SUBJECT: **NEW VEHICLE DEMONSTRATION / DELIVERY HOLD**
Compliance Recall 22C20 - Supplement #1
Certain 2022 Model Year Maverick
Side Airbag Curtain Replacement

New! REASON FOR THIS SUPPLEMENT

CERTAIN 2022 MODEL YEAR MAVERICK VEHICLES — DRIVER AND PASSENGER SIDE CURTAIN AIRBAG REPLACEMENT

FIGURE 19

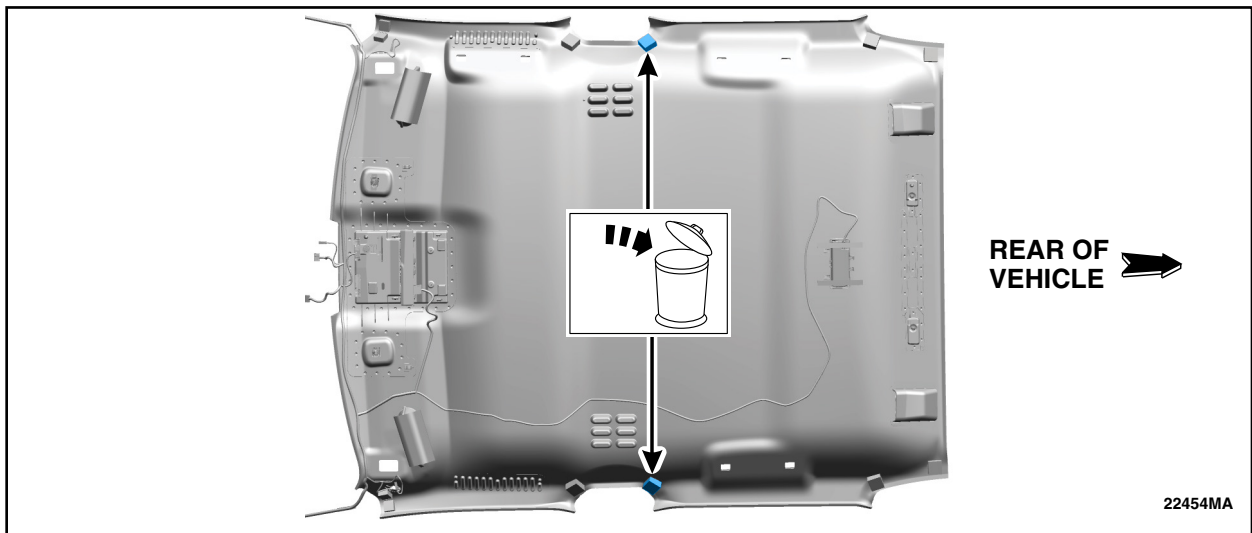
NEW ! 22. On both sides of the headliner, remove and discard the foam block located rearward of the B-Pillar upper trim panel. *See Figures 18 and 19.*

FIGURE 21

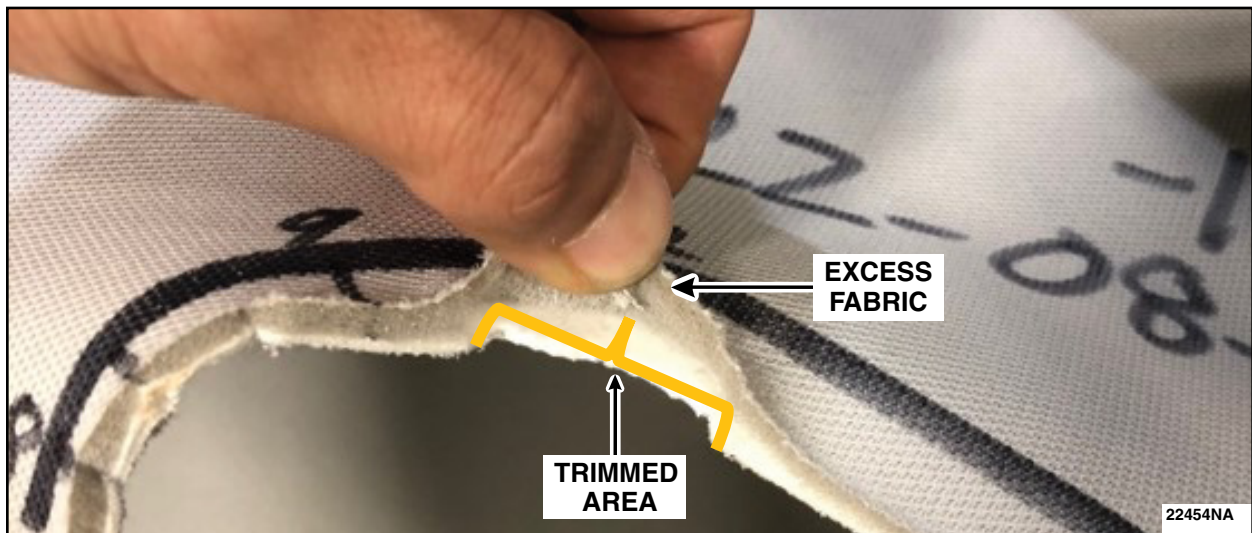
23. On both sides of the headliner, measure inward 0.11 in (3mm) across the three *triangular* notches from the edge of the headliner rearward of the B-Pillar upper trim panel and using a suitable tool remove the excess material *including the three triangular notches*. See Figure 20.

NOTE: Excess fabric is acceptable and will be covered when the B-Pillar is reinstalled. See Figure 21.

FIGURE 25

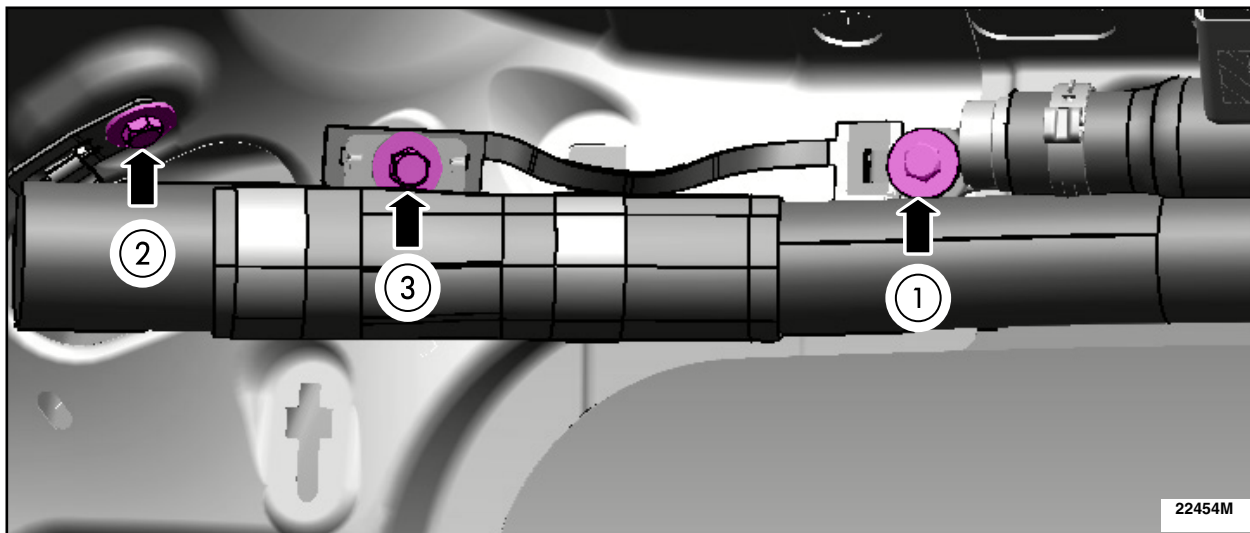
27. Install the side curtain airbag rear bolts *in the sequence shown*. See Figure 25.

FIGURE 26

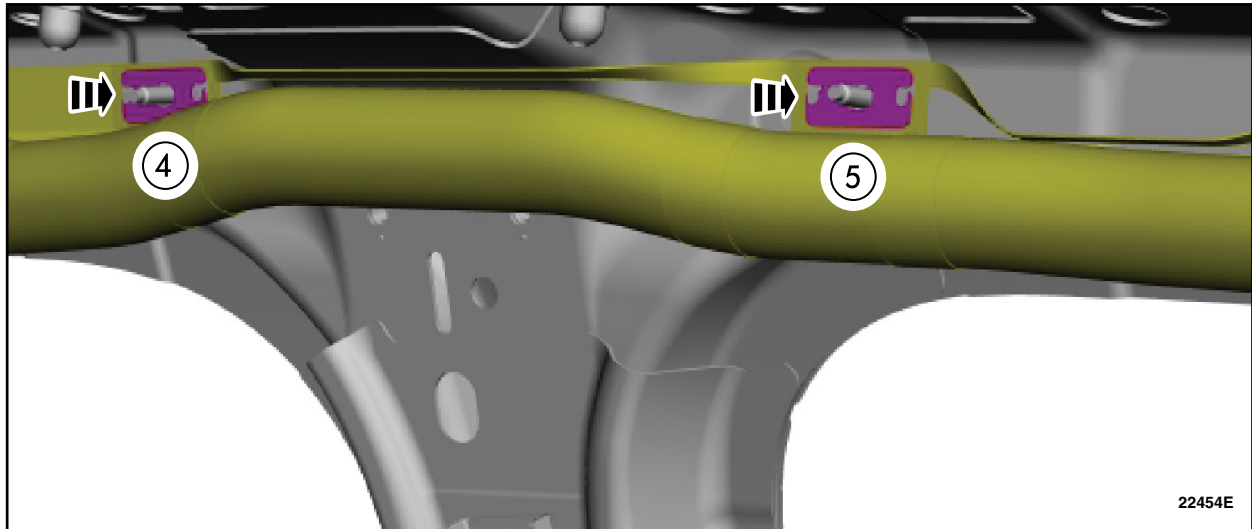
28. Attach the *new* side curtain airbag to the hangers *in the sequence shown*. See Figure 26.

FIGURE 27

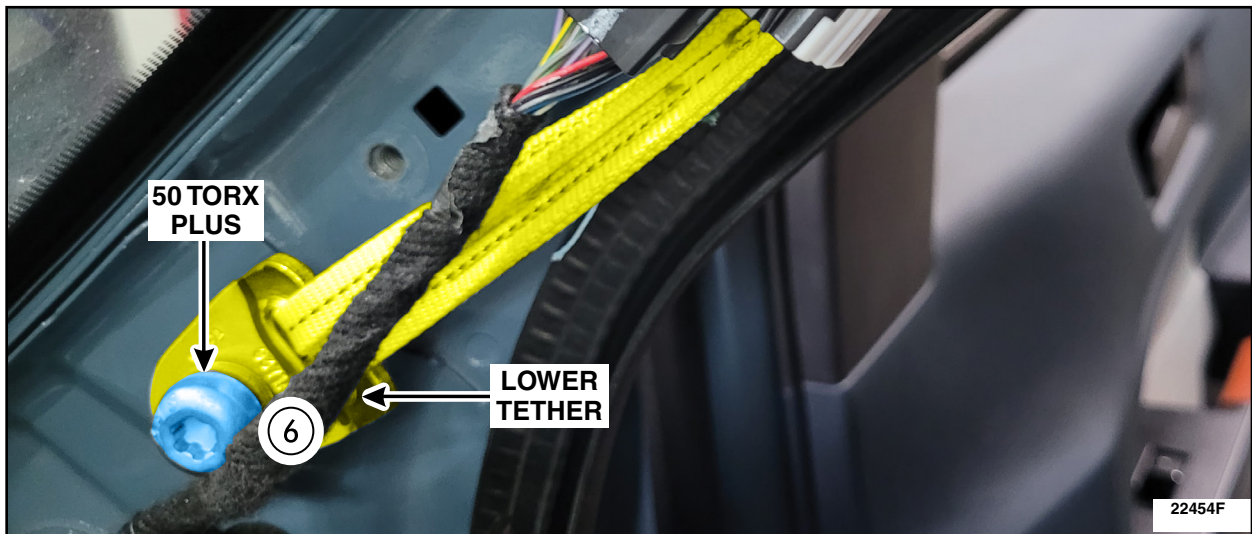
29. Using the *new* 50 torx plus bolt attach the *new* side curtain airbag lower tether *and hand tighten the bolt*. See Figure 27.
